W3F1-2021-0032

Subject: Revised License Amendment Request - Digital Upgrade to the Core Protection Calculator (CPC) System and Control Element Assembly Calculator (CEAC) System

> Waterford Steam Electric Station, Unit 3 NRC Docket No. 50-382 Renewed Facility Operating License No. NPF-38

Evaluation of the Proposed Change <u>Revision 1</u>

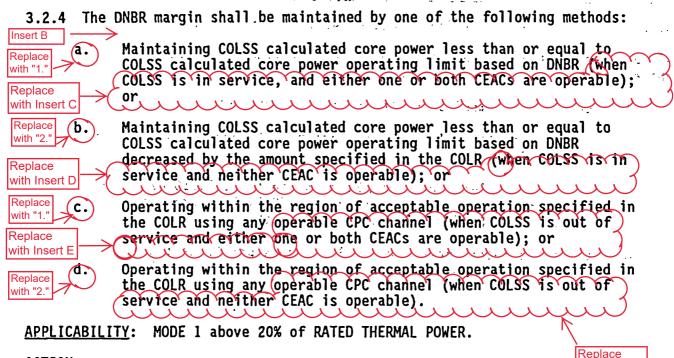
Delete

TS 3.1.3.1 SR 4.1.3.1.1	The Surveillance Requirement 4.1.3.1.1 listed in TS 3.1.3.1 contains the only change to this TS. The operability requirements of the CEAs are not impacted. The objective of the SR is also unchanged. The proposed change removes the current TS guidance on how often the SR should be performed depending on the operability condition of the CEACs. This guidance is redundant to the proposed TS 3.3.1 Action 6 statement which dictates when CEA position checks are performed depending on CEAC operability status. As described below, Action 6 directly stipulates performance of SR 4.1.3.1.1 on the same 4 hour frequency as is currently required.
TS 3.2.4	TS 3.2.4 is reformatted to resemble the PVNGS TS 3.2.4 wording, by grouping the four methods of monitoring DNBR depending on the status of the Core Operating Limit Supervisory System (COLSS). The PVNGS LCO wording was chosen because it concisely handles the eight CEAC configuration design and functionality impacts. It was previously reviewed and approved by the NRC, which is described in Section 4.2, "Precedent". The actions to take when the DNBR limit is not maintained are unchanged from the present Waterford TS 3.2.4.

SURVEILLANCE REQUIREMENTS (Continued)

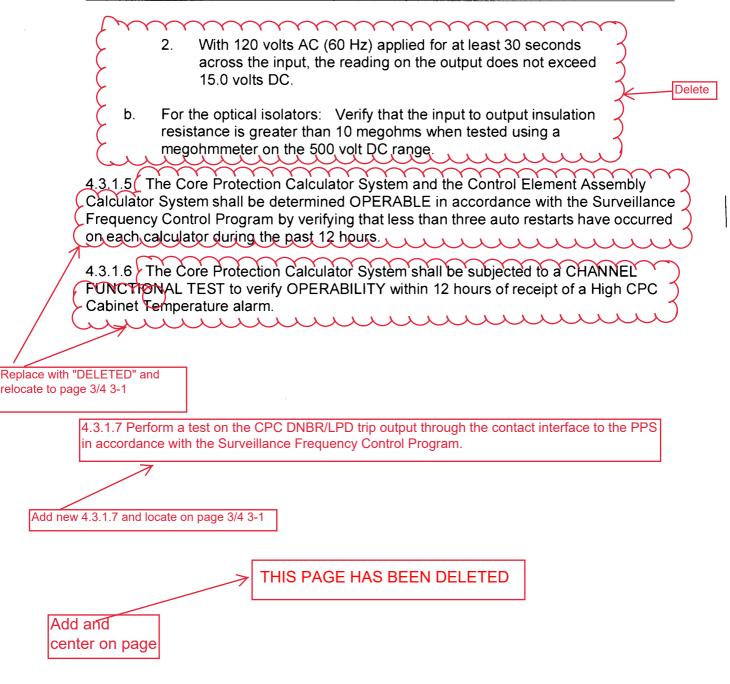
4.3.1.3 The REACTOR TRIP SYSTEM RESPONSE TIME of each reactor trip function shall be demonstrated to be within its limit in accordance with the Surveillance Frequency Control Program. Neutron detectors are exempt from response time testing. Each test shall include at least one channel per function such that all channels are tested as shown in the "Total No. of Channels" column of Table 3.3-1. Replace with Insert G

TS 3.3.1 SR 4.3.1.3	SR 4.3.1.3 is modified to also exclude CPC and CEAC, along with neutron detectors, from REACTOR TRIP SYSTEM RESPONSE TIME testing. The response time assumptions of the CPCS Upgrade will be validated as part of the Site Acceptance Testing. Appendix B to the LTR provides the justification for this change.
TS 3.3.1 SR 4.3.1.4	SR 4.3.1.4 is no longer applicable, due to design changes, since isolation amplifiers and optical isolators are being replaced with fiber optic cabling which is qualified by Entergy, as described in LTR Section 6.2.2.19. The text of the SR is replaced with "DELETED".
TS 3.3.1 SR 4.3.1.5	SR 4.3.1.5 is no longer applicable since the upgraded CPCS design, using the Common Q platform, does not include the auto restart feature. The text of the SR is replaced with "DELETED".
TS 3.3.1 SR 4.3.1.6	SR 4.3.1.6 to perform a CHANNEL FUNCTIONAL TEST within 12 hours of receipt of a High CPC Cabinet Temperature alarm is being deleted. The basis for the removal of this SR is provided in Appendix B to the LTR

ACTION STATEMENTS

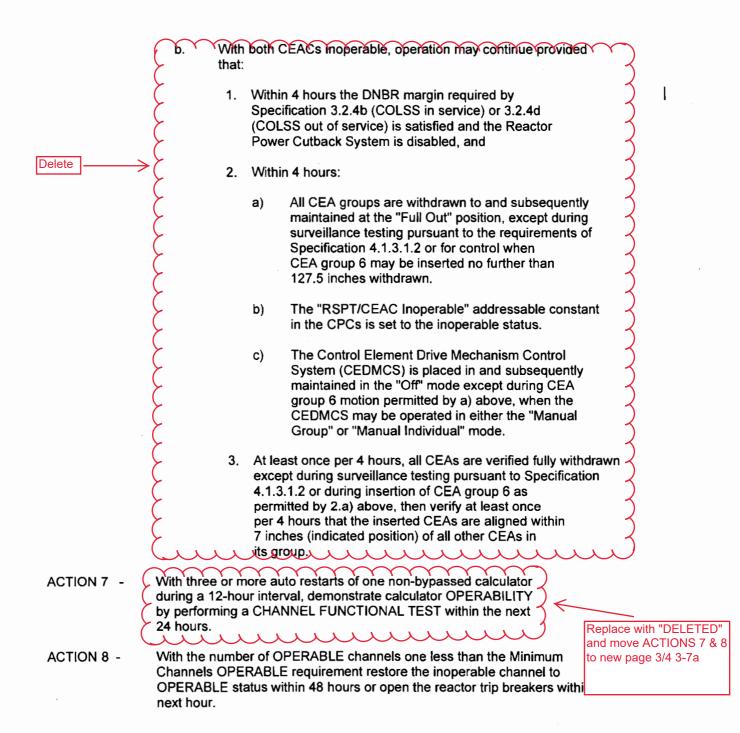
Replace with Insert I and Move Action 6 to page 3/4 3-7

· · · · · · · · · · · · · · · · · · ·	
	CEACs, while maintaining an understandable presentation of the Actions, the current two part Action 6 is being revised to describe three CEAC operability conditions. The addition of a NOTE indicates that separate entries may be made for each CPC.
	Action "a" is new and reflects the robustness of the CPCS design such that up to two CPC channels maintain full capability with only a single CEAC OPERABLE in each. The action consists of ensuring the affected CPC channels does not use the input from the failed CEAC by manually setting the appropriate addressable constant. From a safety function perspective, the CPCS is fully capable of meeting all functional requirements. This is because the CEAs in each subgroup are monitored by redundant reed switch position transmitters (RSPT 1 and RSPT 2). CEAC 1 in each CPCS channel is identical and therefore redundant in four CPCS channels. It monitors all the CEA RSPT 1 signals to compute a penalty factor for the CPC in case there is a CEA deviation in a subgroup.

REACTOR PROTECTIVE INSTRUMENTATION SURVEILLANCE REQUIREMENTS

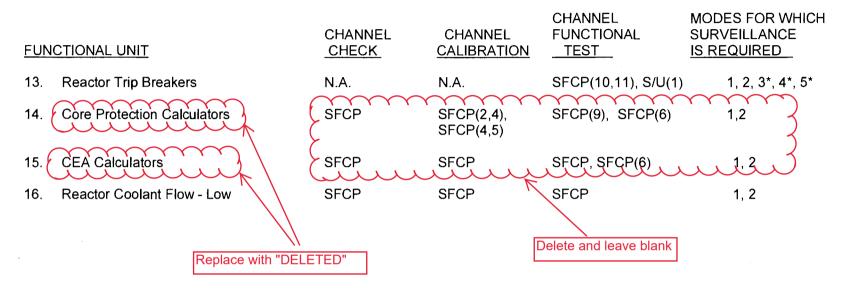
Replace with
